Service Bulletin

S.B. No: 187

Title: INSPECTION FOR CLEARANCE BETWEEN RUDDER PEDAL AND MIXTURE/PROP. SPEED BRACKET AND FOR GROUND TOWING DAMAGE. ALSO INCLUDES GENERAL RUDDER PEDAL CLEARANCES.

Applicability: T67M200 (Works No. 2264 & 2265 only), T67M260 and T67M260-T3A.

FIGURE 1A
SHOWING CLEARANCE TO PRE MOD M1030 MIXTURE/PROP SPEED BRACKET TO No. 3 PEDAL

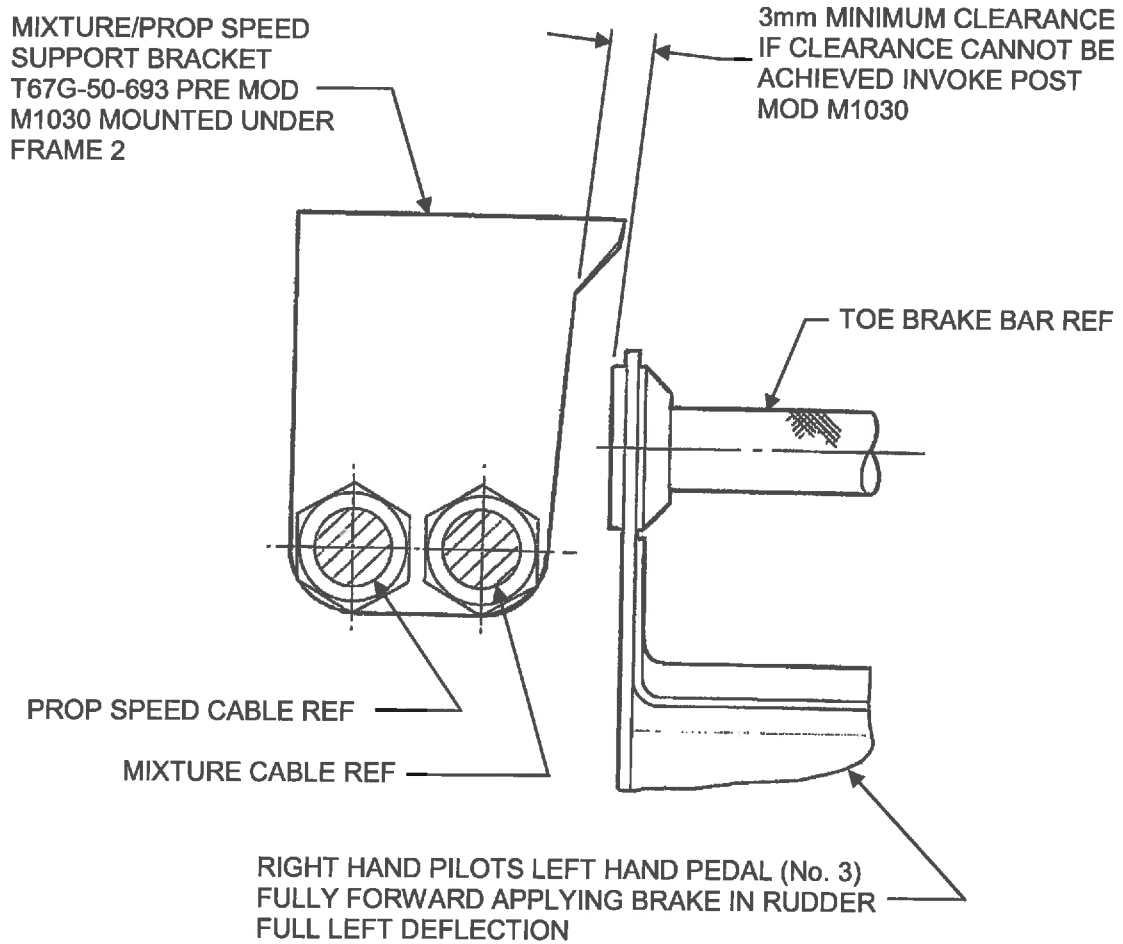
3. Clearance should be a minimum of 3mm, Figure 1A refers, Pre Mod M1030, or minimum of 10mm, Figure 1B refers, if Post Mod M1030 incorporated.
 - 3.1 Pre Mod M1030: If the clearance is less than 3mm, then Change M1030 "Introduction of Revised Propeller Speed Bracket for Increased Rudder Pedal Clearance" shall be invoked and the following inspections and corrective actions, paragraphs 4 to 34, shall be carried out in order to ensure that the 10mm minimum clearance of Post Mod M1030 is obtained.

FIGURE 1B
SHOWING CLEARANCE TO POST MOD M1030 MIXTURE/PROP SPEED BRACKET TO No. 3 PEDAL

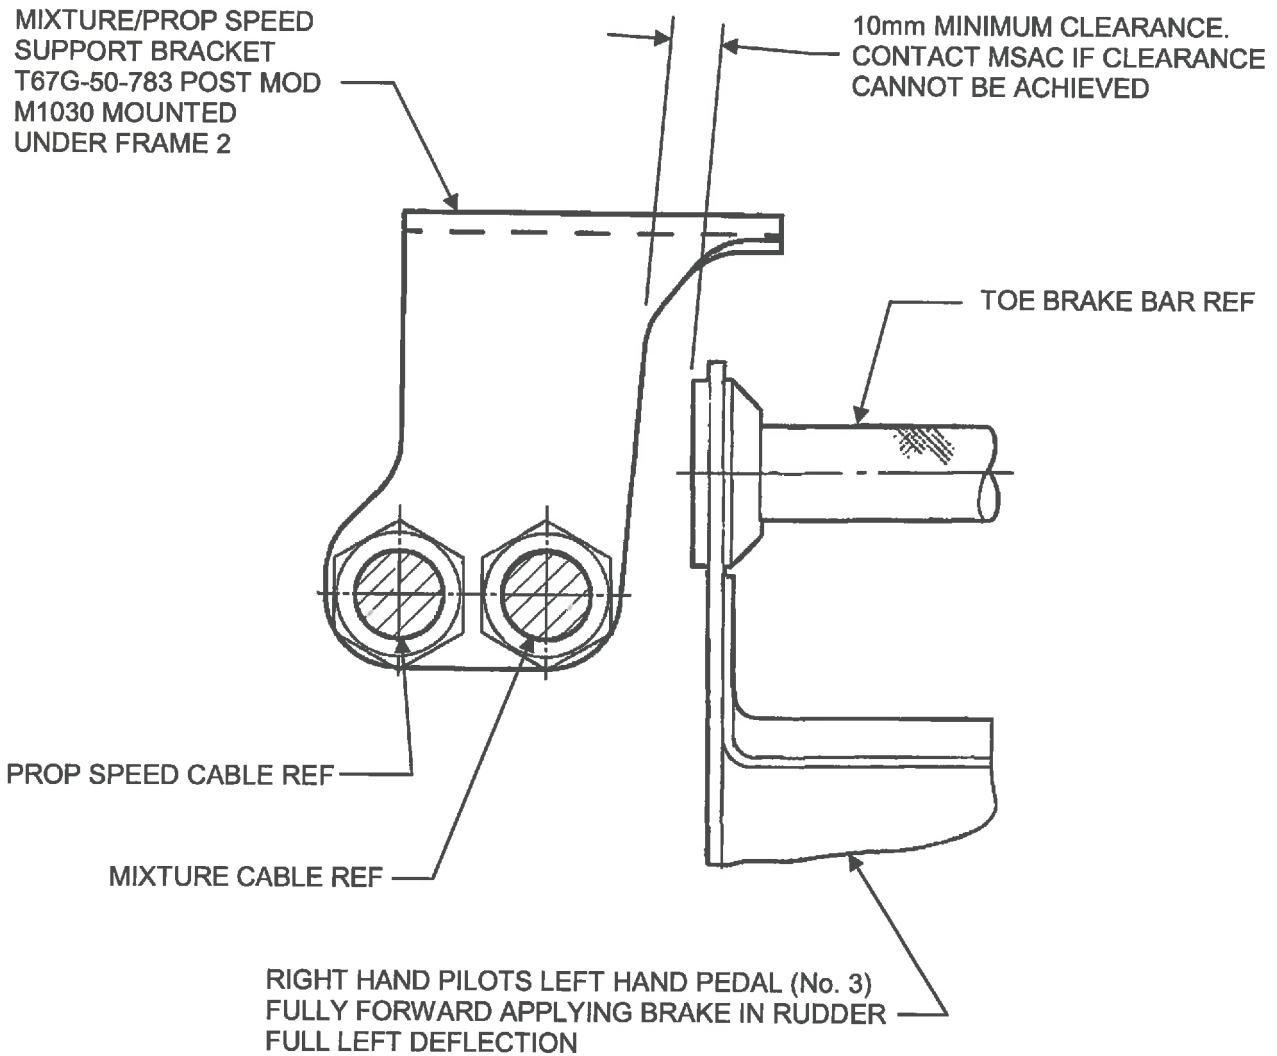
- 3.2 Post Mod M1030: If the clearance is less than 10mm, then the following inspections and corrective actions, paragraphs 4 to 34, shall be carried out in order to ensure the minimum clearance of 10mm is obtained.

FIGURE 2

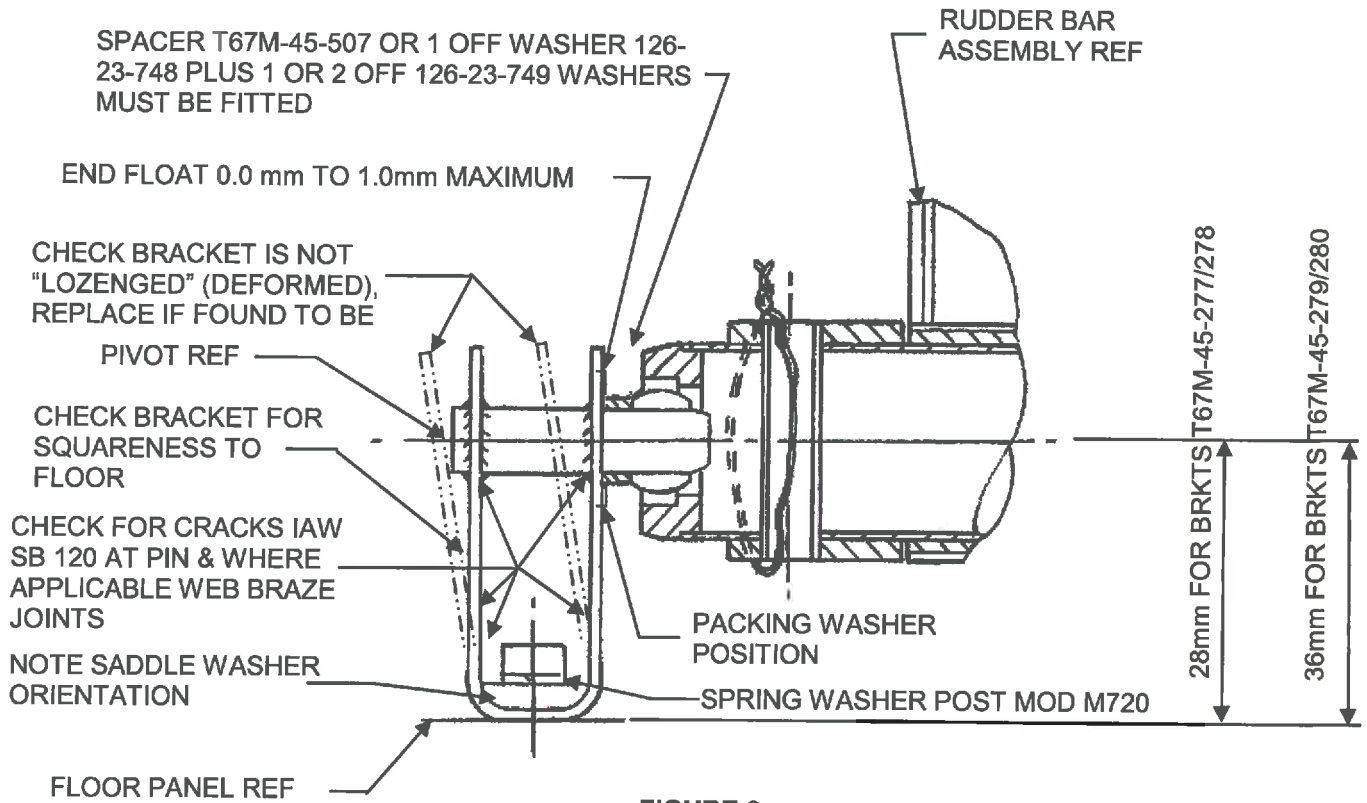
5. Check rudder pedal bar end float is no greater than 1.0mm. Acceptable end float is 0.0mm to 1.0mm. If end float is greater than 1.0mm then rectify IAW paragraph 16. Refer Figure 2.

16. Referring to Figure 2 ensure at each rudder bar pivot position that there is one spacer T67M-45-507 or one off washer 126-23-748 and up to a maximum of two off washers 126-23-749, i.e. 3 washers maximum.

If end float greater than 1.0mm, then 1 off packing washer may be added at each pivot position as required, i.e. 126-23-105 washer or 126-23-748 washer or 126-23-749 washer.

FIGURE 3A

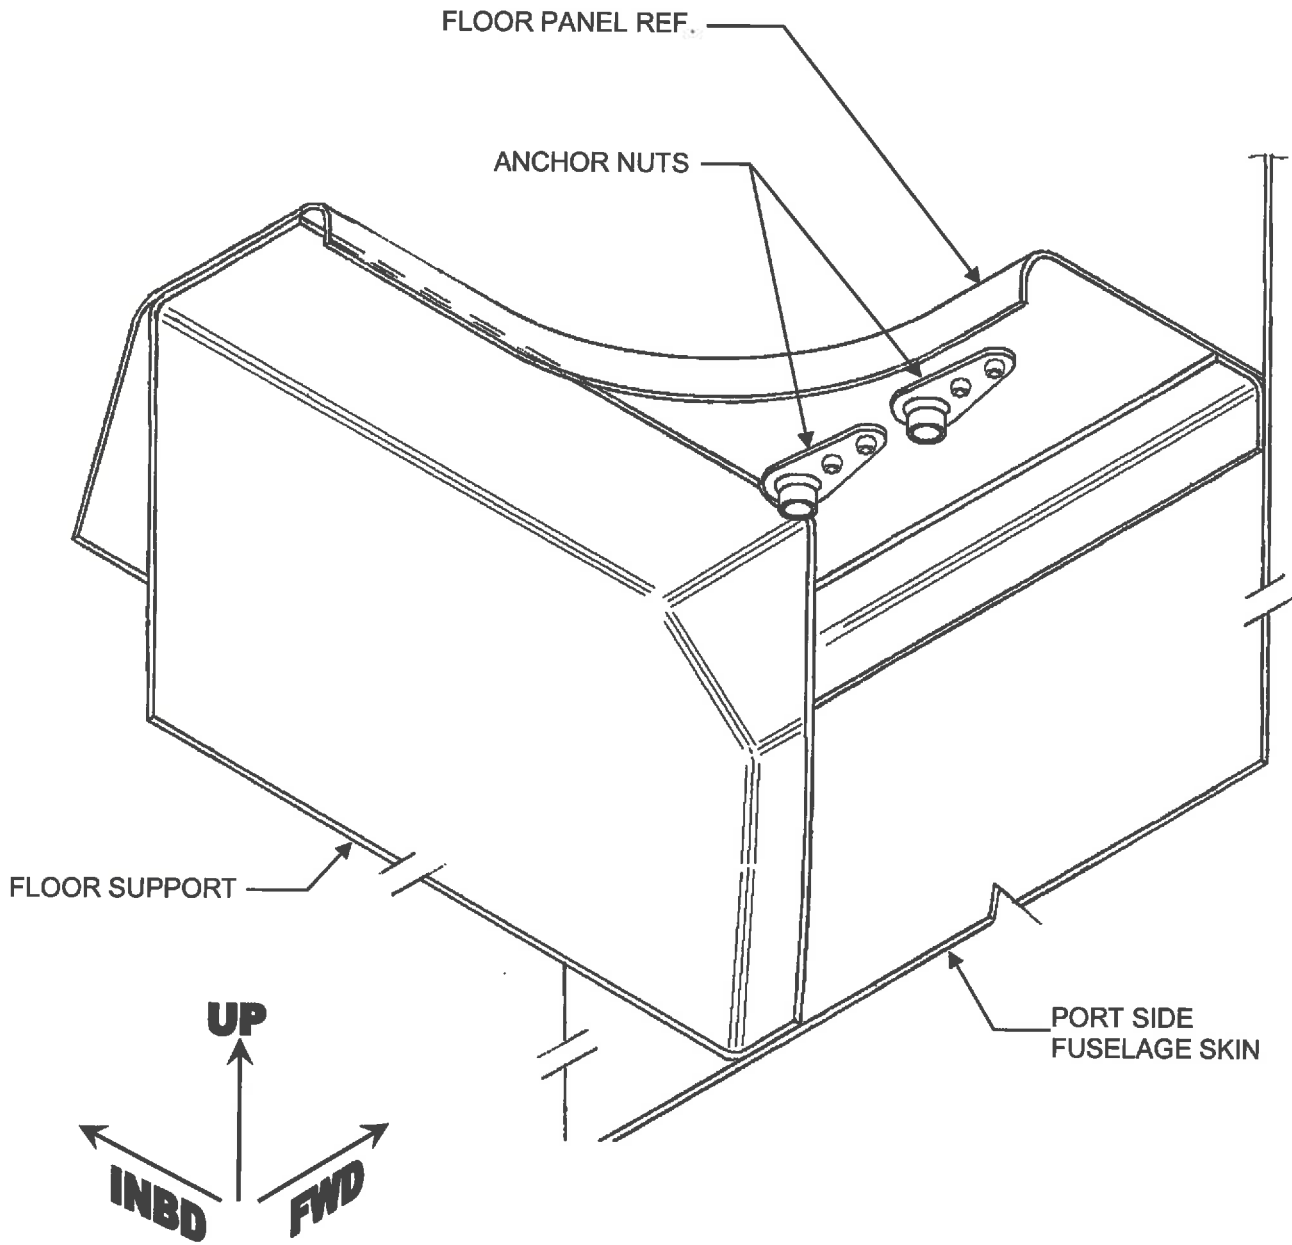
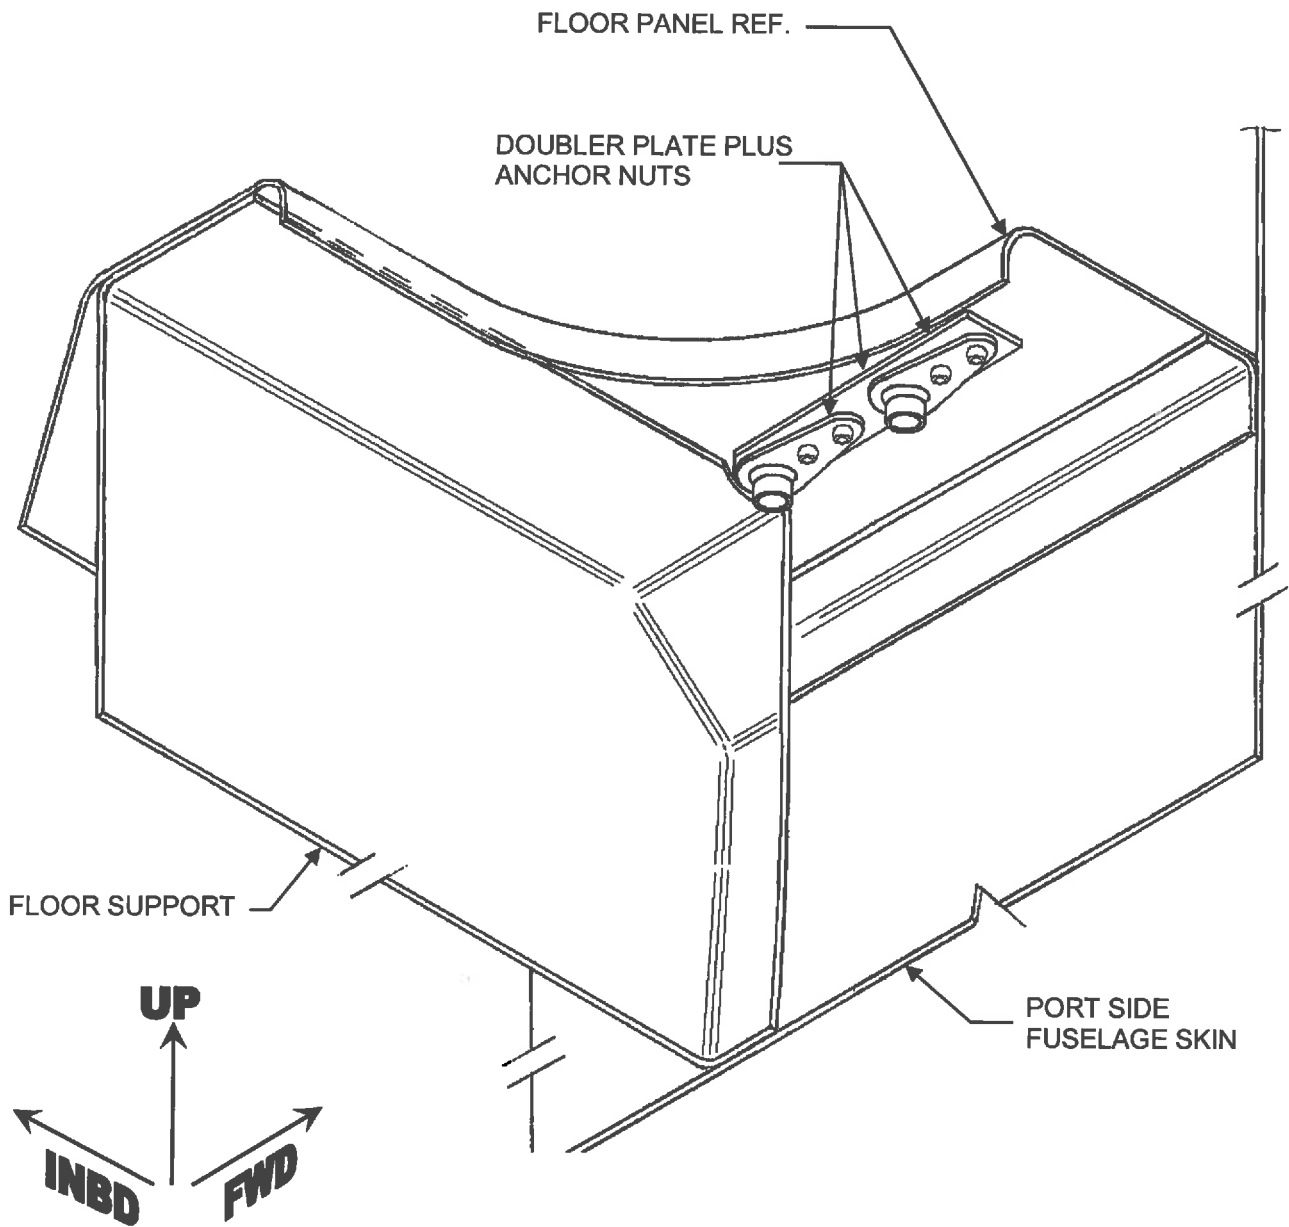
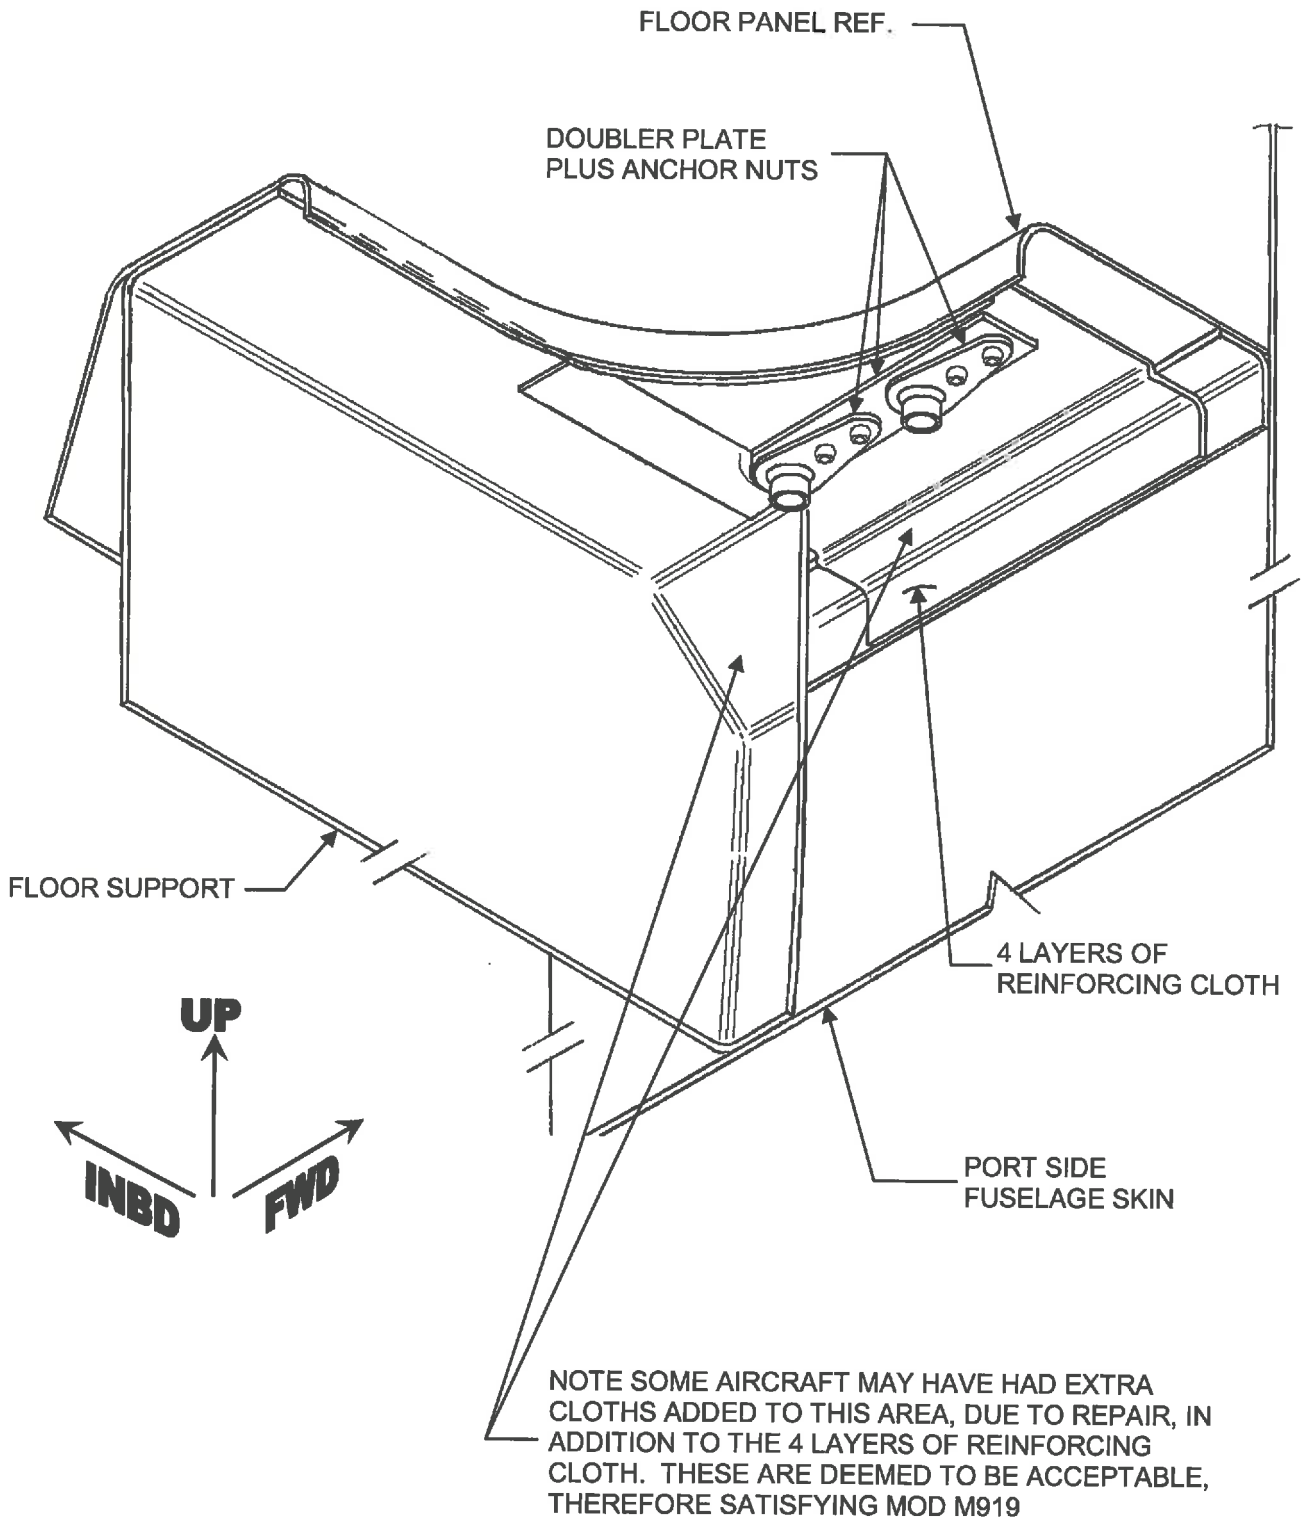
7. Establish Mod status of floor with regards to whether full incorporation of Mod M919 has been implemented as per DOI T67C-149 issue 5, Figure 3C refers. Un-modified floor will be as shown by Figure 3A. Aircraft Modified IAW DOI T67C-149 issue 1, i.e. only doubler plate fitted, see Figure 3B. If T67C-149 issue 5 has been recorded incorporated, then there is no further requirement to remove panels with respect to this Service Bulletin unless damage is noted during course of the inspection, an incident or noted during normal maintenance.

8. If floor under port outboard support bracket position is found to be cracked or broken or not modified IAW Mod M919 Figure 3C, then repair IAW DOI T67C-149 issue 5 and subsequent, to fully incorporate Mod M919. If the full Mod M919 has been previously incorporated i.e. to DOI T67C-149 issue 4 and floor is found to be damaged, inform MSAC.
